Work Order ID 135864

Item Name: QR Heli-Utility-Basket™, Short, HD Lid, Spacepod™ & Squirrel Cheek Comp., LH/RH

DART SERVICE INSTRUCTION

TO AMEND INSTALLATION INSTRUCTIONS D350-607-3 Rev.D,
INSTALLATION INSTRUCTIONS D350-607-4 Rev. C AND
INSTRUCTIONS FOR CONTINUED AIRWORTHINESS ICA-D350-607 REV. 6
REF TCCA STC: SH94-14
REF FAA STC: SR00213NY
REF EASA STC: EASA.10016996
REF BRAZILIAN STC: 2007S03-03/-04/-05/-06

FIGURE 1: INSTALLATION OF D4775-041 FWD STRUT

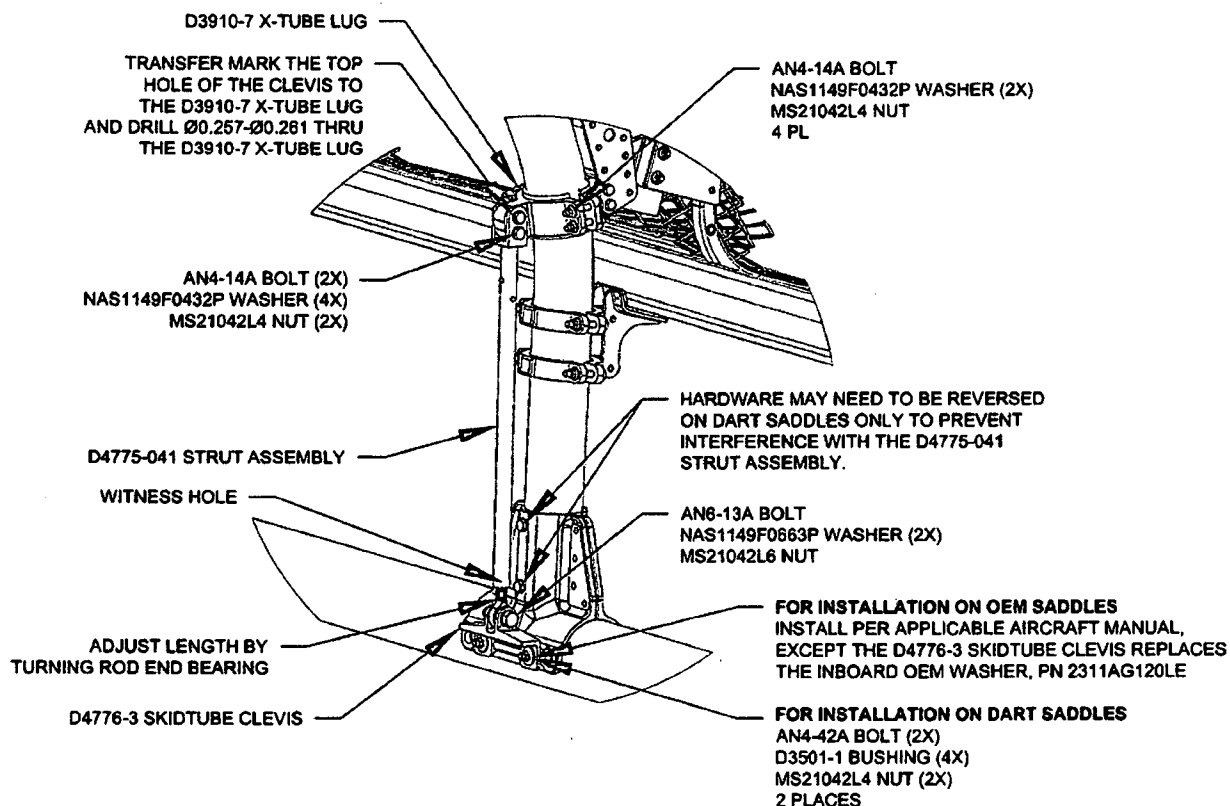
3.1 Substitute the Forward Lower D3910-5 X-Tube Lug with the D3910-7 X-Tube Lug as shown in Figure 1.

3.2 Install the forward D4775-041 Strut Assembly. Transfer mark from the upper hole on the clevis of the D4775-041 Strut Assembly to the D3910-7 X-tube Lug and drill thru the lug $\varnothing 0.257$ - $\varnothing 0.261$ as shown in Figure 1. Touch up chemical conversion coating per MIL-DTL-5541. Check the witness holes located at the bottom end of the D4775-041 Strut Assemblies to ensure that the thread from the rod end extends past the witness hole.
Torque MS21042L4/-4 nuts to 50-70 in-lbs (5.7-7.9 N-m). Torque MS21042L6/-6 nuts to 160-190 in-lbs (18.1-21.5 N-m).
